REQUEST FOR INFORMATION **DATE:** July 20, 2017 **NO.:** RFI-592

Project Name: 15051-Webster University Interdisciplinary Science Building

Subject: Opening at Stair 1 Stringer

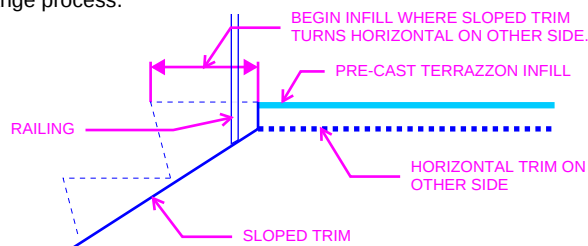
Per discussion between Paric and Cannon on-site on 7/18, the area between the stringer and building structure at the main floor landings will be closed off with 1/8" break metal per detail 2/A0501.B. If this infill area is desired to be raised up to the same elevation as the surrounding floor then please provide a detail. See attached photos.

**INFILL AREA FLUSH WITH THE ADJACENT FLOOR WITH PRE-CAST TERRAZZO.
SEE COMMENTS ON ATTACHED PHOTOS.**

INFILL SHOULD BEGIN AT THE END OF SLOPED TRIM WHEN IT TURNS HORIZONTAL.

PROVIDE CONTINUOUS STRUCTURAL SUPPORT (ANGLE) UNDERNEATH THE INFILL TO SUPPORT THE PRE-CAST TERRAZZO INFILL.

7 STAIR 1 ENLARGED SECTION

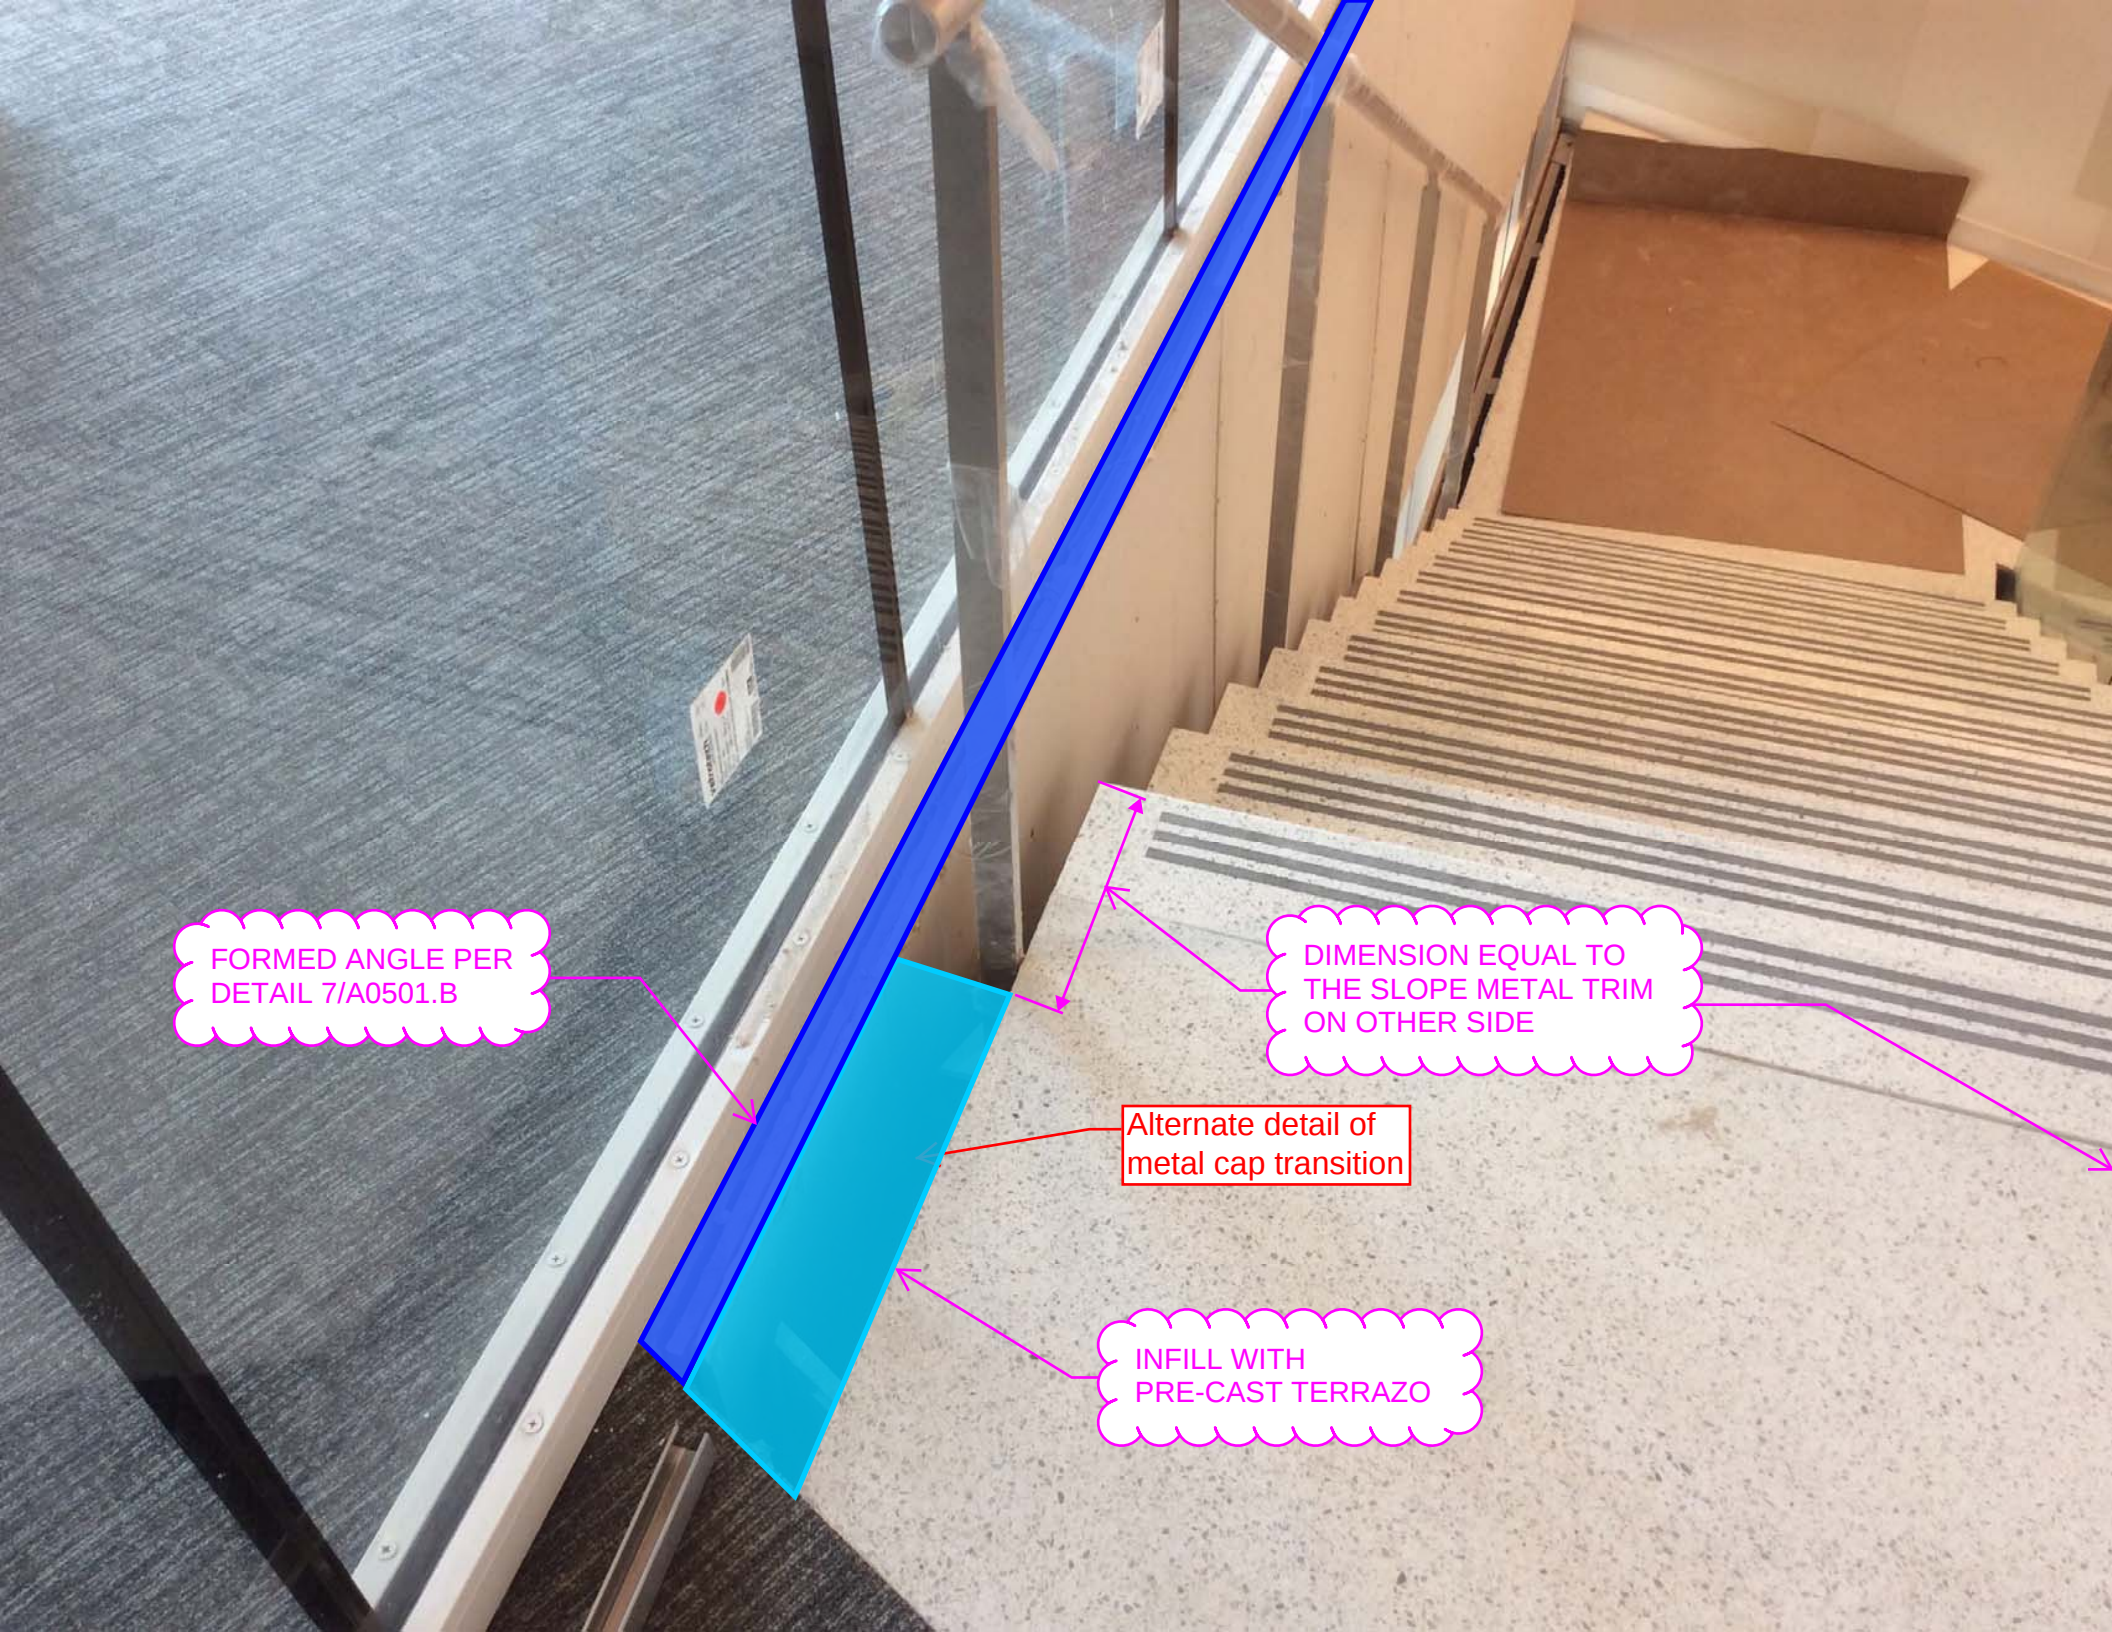
Alternate detail of
metal cap transition

Alternate detail for
2nd floor infill?

FORMED ANGLE PER
DETAIL 7/A0501.B

DIMENSION EQUAL TO
THE SLOPE METAL TRIM
ON OTHER SIDE

INFILL WITH
PRE-CAST TERRAZO

DIMENSION EQUAL TO
THE SLOPE METAL TRIM
ON OTHER SIDE

INFILL WITH
PRE-CAST TERRAZO

FORMED ANGLE PER
DETAIL 7/A0501.B
